# PRODUCT CHANGE NOTIFICATION

## Bourns® EMS Non-Contacting Absolute Encoder Connector Change

### *Model EMS22A and EMS22Q Series*

## Comparison

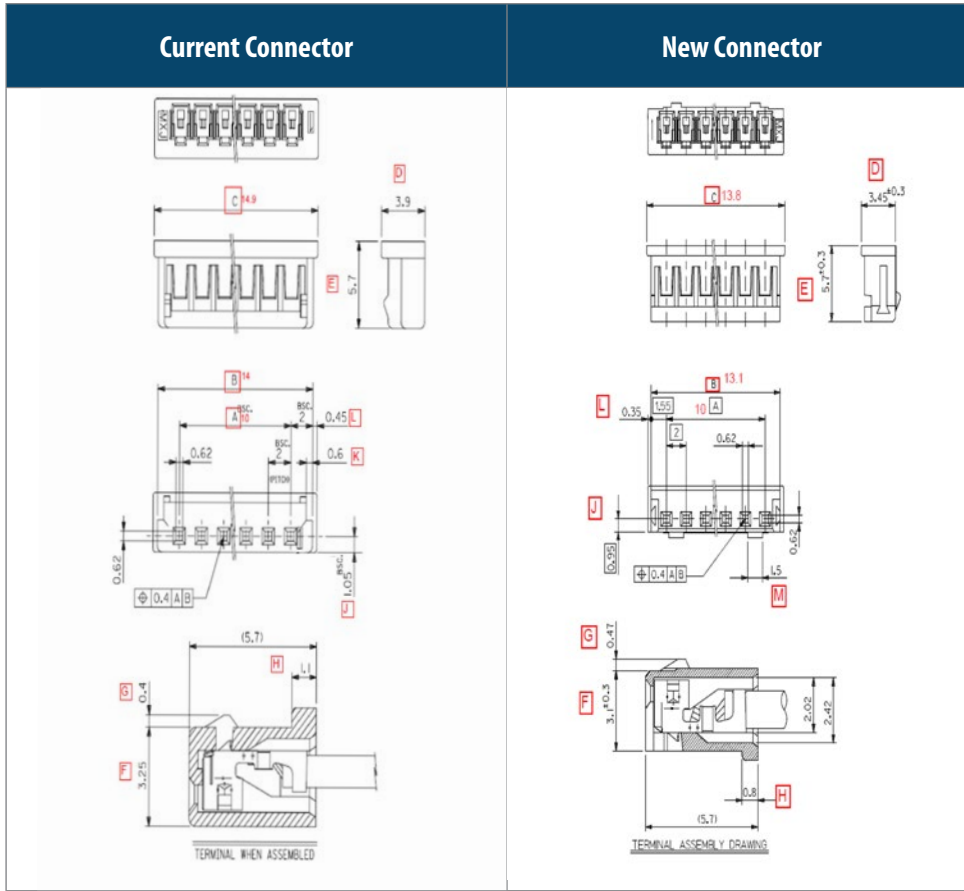
Riverside, California – May 26, 2020 – Effective immediately, the connector used for the Bourns® Model [EMS22A](#) and [EMS22Q](#) series will be changed to the Molex 051065-0600. The current connector has been discontinued by the manufacturer. The dimensions of the Molex 051065-0600 are slightly different than the original connector but the replacement connector is made with comparable materials. The change in dimensions shown on the following page could impact the customer's application. Affected part numbers are listed below.

The change in dimensions will affect the form and fit of the product. This change will have no effect on the function, quality or reliability. Samples for evaluation are available upon request.

Description	Current P/N: 051090-0600	Replacement P/N: 051065-0600	Replacement meets spec
<b>Agency Certification</b>			
CSA	LR19980	LR19980	✓
UL	E29179	E29179	✓
<b>Physical Specification</b>			
Color - Resin	Natural	Natural	✓
Flammability	94V-0	94V-0	✓
Gender	Receptacle	Receptacle	✓
Glw-Wire Capable	No	No	✓
Material - Resin	Polyester	Polyester	✓
Net Weight	197.000/mg	159.700/mg	✓
Number of Rows	1	1	✓
Pitch - Mating Interface	2.00mm	2.00mm	✓
Temperature Range - Operating	-40° to +105°C	-40° to +105°C	✓
<b>Dimensional</b>			
DIM A	10	10	✓
DIM B	14	13.1	X
DIM C	14.9	13.8	X
DIM D	3.9	3.45 ± 0.3	X
DIME	5.7	5.7	✓
DIM F	3.25	3.1	X
DIM G	0.4	0.47	X
DIM H	1.1	0.8	X
DIM J	1.05	0.95	X
DIM K	0.6	missing	X
DIM L	0.45	0.35	X
DIM M	missing	1.5	X

Dimension: MM  
**Note:** For this replacement the mating connector must be changed to manufacturer series P/N: 53253 or P/N: 53254
